GAME: Johnny Mnemonic (first 100 games manufactured)

SUBJECT: Updating game with production modifications

Installing Insulation Between Back Panel Flashlamp Terminals

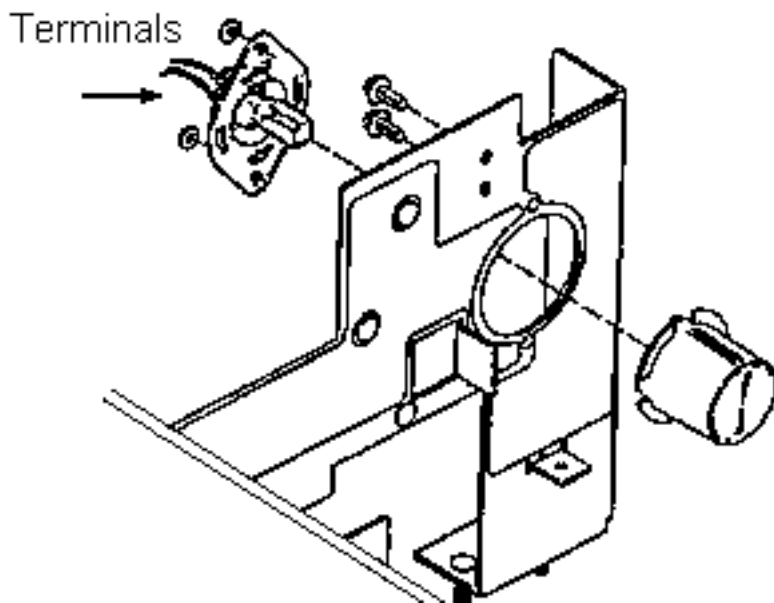
Due to variations in harness dressing on the back panel bracket, it is possible for the terminals on the right hand flash lamp to become deformed and eventually short together as a result of lifting the playfield. This will cause FUSE 111 to blow.

The solution to this problem is to insulate one or both of the flash lamp terminals from the other. Use electrical tape or heat shrink tubing for insulation.

Installing Magnet Wire Clip

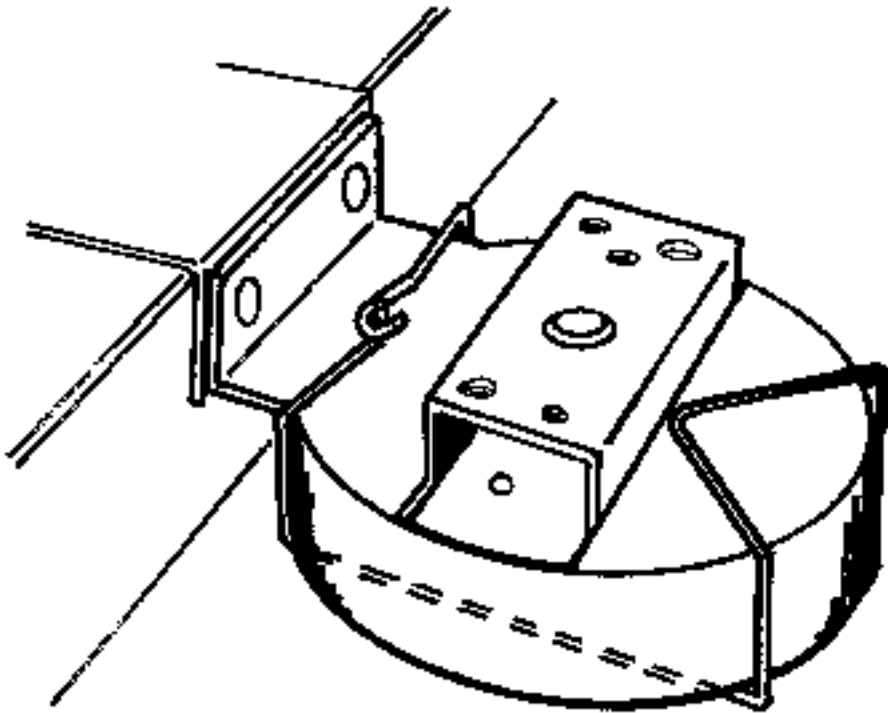
Wire clip (part number 12-7331) should be installed to prevent magnet from coming loose from housing. Wire clip may be installed without removing the black vinyl hand, however removing the vinyl hand makes it easier to install.

Install the wire retaining clip as shown. (Note: The switch is not shown for clarity.)
